Product Change Notice (PCN)

PCN Number: **PCN-0451151R-01**

Product(s) Affected: PJ-037BH

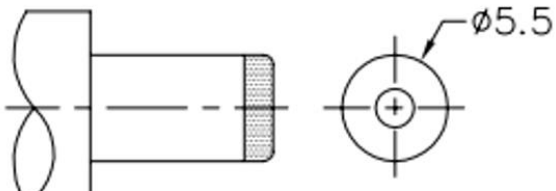
Description of Change: mechanical differences as shown below:

MATERIAL	PLATING
center pin	copper	nickel
terminal 1	brass	silver
terminal 2	copper alloy	silver
plastic	PBT

DESCRIPTION	MATERIAL	PLATING/COLOR
center pin	copper alloy	nickel
terminal 1	brass t=0.3 mm	nickel-silver
terminal 2	phosphor bronze t=0.3 mm	nickel-silver
housing	PBT (UL94V-0)	black
cover	PBT (UL94V-0)	black

MATING PLUG
Jack Insertion Depth: **9.0 mm**

MATING PLUG
Jack Insertion Depth: **9.8 mm**

Insertion/extraction force adjusted to 0.3 ~ 2.0 kg
